**PLANNING COMMISSION
STAFF REPORT**

AGENDA ITEM: **Planning File No. MAJ-26-0002:** A sketch plan review of the Major Site Plan application for a proposed residential development consisting of eight (8) new townhomes and one existing home to remain.

LOCATION: 40 and 42 Granite Street / Lots 6-12, Block 3, King Solomon Sub #2

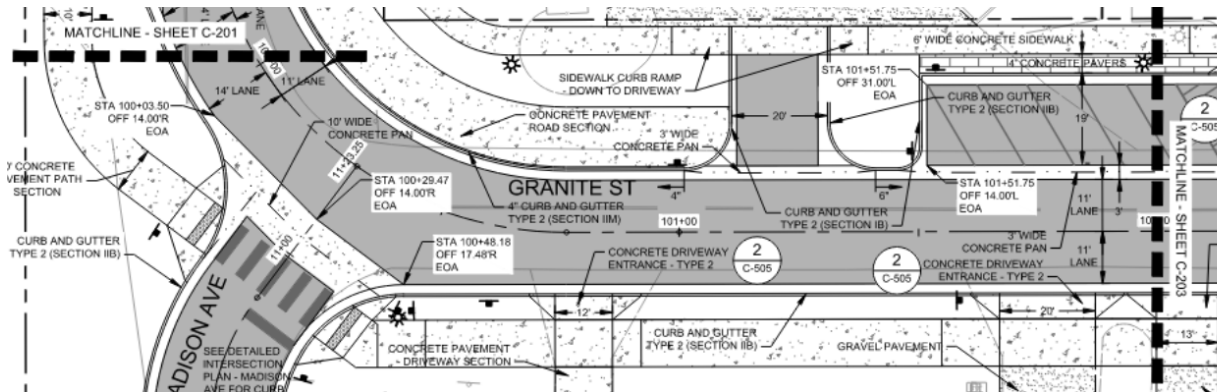
The application materials show internal sidewalks connecting each unit to an internal courtyard and walkways connecting each unit to the nearest public street. These walkways must be paved.

In comments from Summit County Engineering, they noted that pedestrian connections to County roads are not historically allowed without existing pedestrian accommodations in the right-of-way, such as the walkway coming from Unit 4. They recommend the walkway from Unit 4 connecting to the alley or another location outside the County right-of-way.

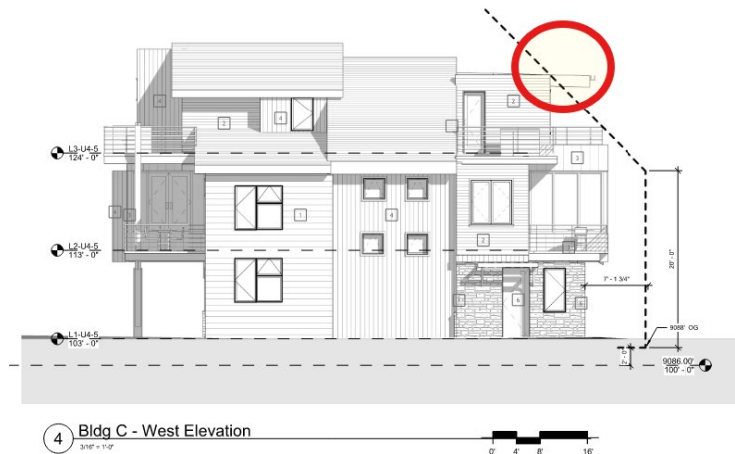
The application appears to meet this standard, but the final determination will be made at the review of the final site plan application.
